My name is Samuel Miranda. I submitted the enforcement petition that is under your review. It is submitted under the terms of 10 CFR §2.206, and it concerns the licensing and operation of the Byron and Braidwood Stations.

I maintain that Exelon, has obtained the NRC's authorization to operate its Byron and Braidwood Stations at an uprated power level, without demonstrating that its plant designs meet all design requirements, specified in their licensing bases. I am requesting, among other things, that the NRC revoke its uprating approvals, and compel Exelon to operate its Byron and Braidwood Stations at their originally licensed power levels until the required demonstration of compliance is made. The petition describes several issues, in Exelon's LAR and in its licensing basis, that support this request.

Figure 1
AOO Boundary

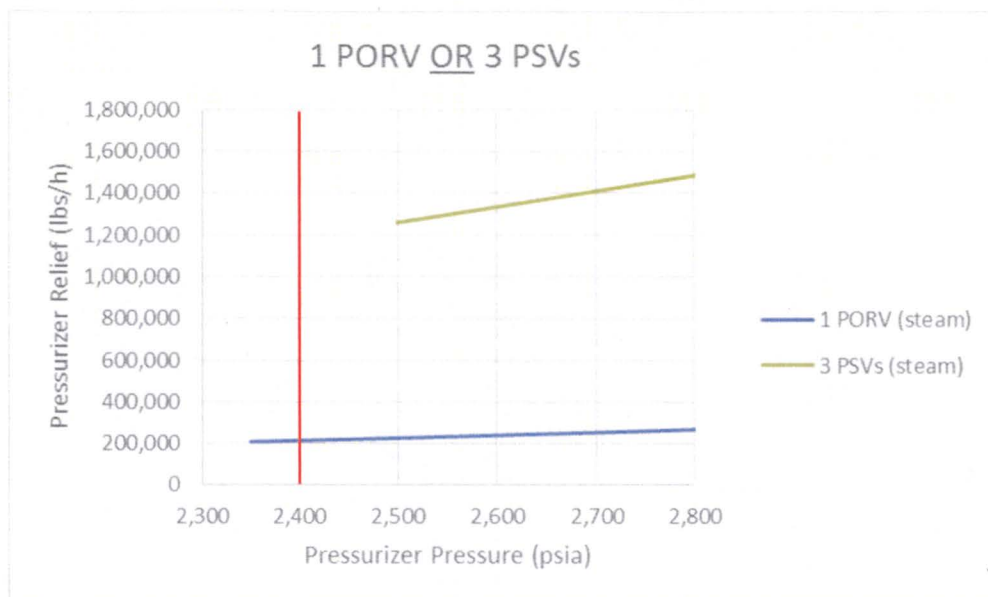
- One PORV is shown to open at 2,350 psia. This is enough to prevent the opening of any PSVs.
- The high pressure reactor trip (marked in red) will occur when pressure exceeds 2,400 psia.

- The PSV opening setpressure is higher than the pressure boundary that defines an AOO (i.e., the 2,400 psia reactor high pressure trip setpoint).
- If pressure continues to increase, after the reactor is tripped, and a PORV does not open, then one or more PSVs would open at 2,500 psia (set to the RCS design pressure).

- Pressure relief would be provided by the PORVs or by the PSVs; but not both.
- Three PSVs have more than six times the steam relief capacity of one PORV.

- AOOs would lie to the left of the red reactor trip line (i.e., pressures below 2,400 psia). If pressure exceeds the reactor trip setpoint (i.e., despite the reactor shutdown), then the reactor shutdown has not accommodated the event. Consequently, the event is not an AOO. So events that lie to the right of the red line are not AOOs. If these events are not AOOs, then they must be Condition III or IV events.

- PSVs cannot open until after the AOO becomes a more serious event (i.e., opening of the PSVs cannot meet the *non-escalation requirement*).

Figure 2
Flow in ≠ Flow out

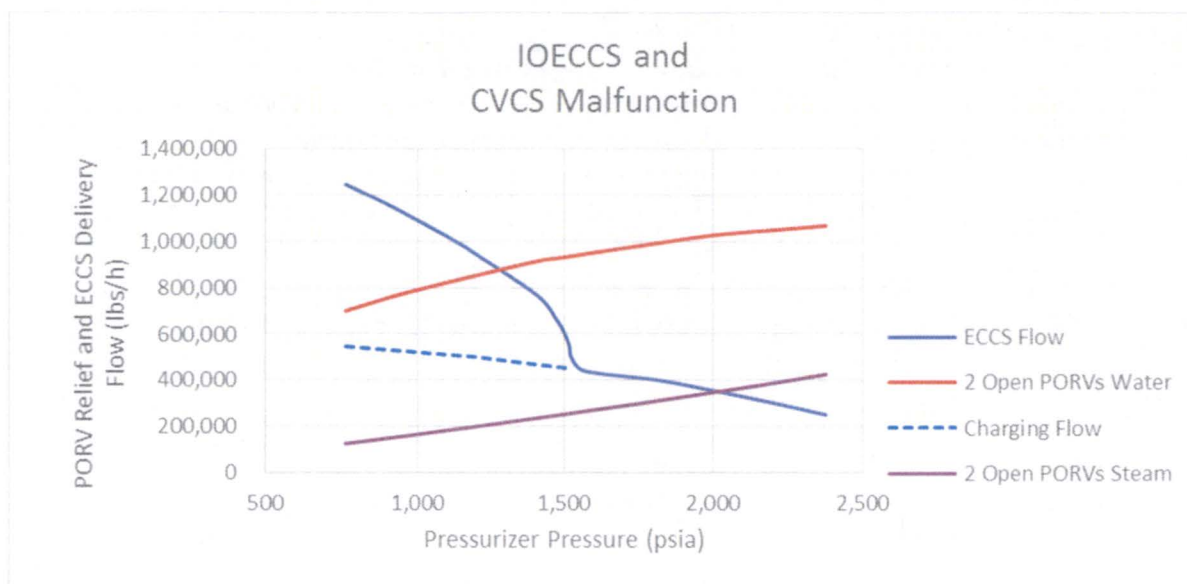
- (1) ECCS (i.e., charging) flow rate will not exceed the PORV steam relief rate until the RCS pressure drops to about 2,000 psia,
- (2) ECCS flow rate will not exceed the PORV water relief rate until the RCS pressure drops to about 1,300 psia, and
- (3) Charging flow rate will not exceed the PORV water relief rate until the RCS pressure drops below the accumulator injection setpoint (about 600 psia).
- (4) One PSV has about twice the steam relief capacity of a PORV, and there are three of them. To estimate the steam relief rate of three stuck-open PSVs, triple the depicted steam relief rate of two stuck-open PORVs.

The pressurizer, during mass addition AOs (e.g., IOECCS and CVCS Malfunction), is not an open system, like a bucket that is running over. It is a closed, pressurized system with a hole in it. The flow exiting through the hole is determined by the size of the hole, and the pressure of the system, not by the flow that may be entering the system. The NSAL's *mass-balance* argument (i.e., what goes in, comes out) contradicts the basic principles of fluid mechanics. Exelon has adopted this rationale, and copied it into its license amendment requests (LARs), and submitted it to the NRC under Oath and Affirmation.

Figure 1
AOO Boundary

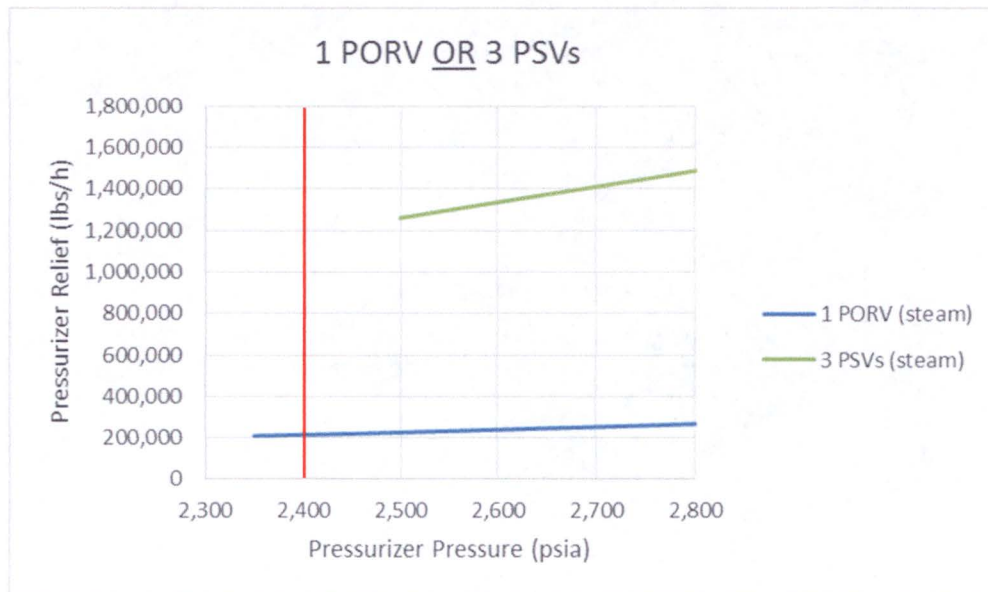
- One PORV is shown to open at 2,350 psia. This is enough to prevent the opening of any PSVs.
- The high pressure reactor trip (marked in red) will occur when pressure exceeds 2,400 psia.

- The PSV opening setpressure is higher than the pressure boundary that defines an AOO (i.e., the 2,400 psia reactor high pressure trip setpoint).
- If pressure continues to increase, after the reactor is tripped, and a PORV does not open, then one or more PSVs would open at 2,500 psia (set to the RCS design pressure).

- Pressure relief would be provided by the PORVs or by the PSVs; but not both.
- Three PSVs have more than six times the steam relief capacity of one PORV.

- AOOs would lie to the left of the red reactor trip line (i.e., pressures below 2,400 psia). If pressure exceeds the reactor trip setpoint (i.e., despite the reactor shutdown), then the reactor shutdown has not accommodated the event. Consequently, the event is not an AOO. So events that lie to the right of the red line are not AOOs. If these events are not AOOs, then they must be Condition III or IV events.

- PSVs cannot open until after the AOO becomes a more serious event (i.e., opening of the PSVs cannot meet the *non-escalation requirement*).

Figure 2
Flow in \neq Flow out

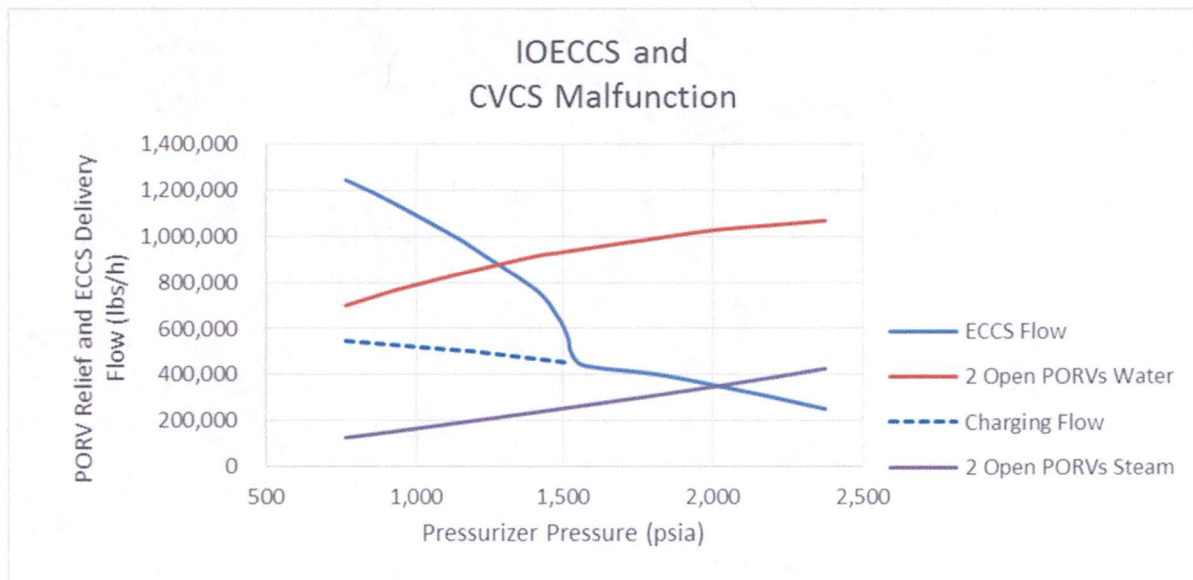
- (1) ECCS (i.e., charging) flow rate will not exceed the PORV steam relief rate until the RCS pressure drops to about 2,000 psia,
- (2) ECCS flow rate will not exceed the PORV water relief rate until the RCS pressure drops to about 1,300 psia, and
- (3) Charging flow rate will not exceed the PORV water relief rate until the RCS pressure drops below the accumulator injection setpoint (about 600 psia).
- (4) One PSV has about twice the steam relief capacity of a PORV, and there are three of them. To estimate the steam relief rate of three stuck-open PSVs, triple the depicted steam relief rate of two stuck-open PORVs.

The pressurizer, during mass addition AOOs (e.g., IOECCS and CVCS Malfunction), is not an open system, like a bucket that is running over. It is a closed, pressurized system with a hole in it. The flow exiting through the hole is determined by the size of the hole, and the pressure of the system, not by the flow that may be entering the system. The NSAL's *mass-balance* argument (i.e., what goes in, comes out) contradicts the basic principles of fluid mechanics. Exelon has adopted this rationale, and copied it into its license amendment requests (LARs), and submitted it to the NRC under Oath and Affirmation.
